June 18, 1999

Refer to: HMHS-B56

In your June 7 letter to Mr. Richard Powers of my staff, you formally requested Federal Highway Administration acceptance of your composite wood/steel IRONWOOD guardrail system at National Cooperative Highway Research Program (NCHRP) Report 350 test level 3 (TL-3). To support this request you had earlier provided Mr. Powers with a May 1999 report prepared by E-TECH Testing Services, Inc., entitled "NCHRP Report 350 Crash Test Results for the IRONWOOD Guardrail," and a videotape of the crash tests that were run.

PLAN END SECTION

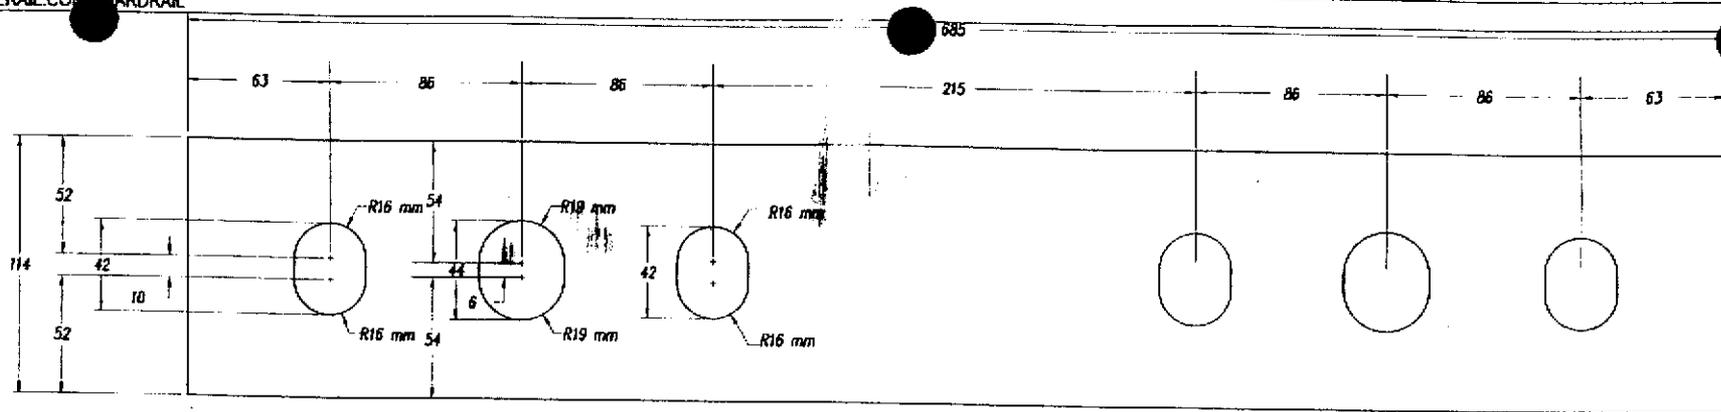
Our second concern is the lack of a tested end-anchor (terminal) for the IRONWOOD Guardrail. As with other aesthetic barriers that have been accepted for use, the preferred end treatment is to terminate the barrier at full height into an existing back slope wherever possible. However, flaring the barrier until the terminal is beyond the appropriate clear zone remains an acceptable treatment.

Unlike other approved aesthetic barrier designs, yours is a weak post system which depends primarily on tensile continuity to function properly. Since the impact point in test 3-11 was near the mid-point of the 128 m installation, impact forces transmitted to the terminal were minimized.

Until you determine the beginning length of need point, or test the guardrail closer to the terminal, we will assume that, for a TL-3 installation, the beginning length of need will be a minimum of 60 m downstream from the terminal. We note that your present terminal has a single-bolt connection to two steel posts driven directly into the ground and appears significantly less substantial than weak post terminals currently in use.
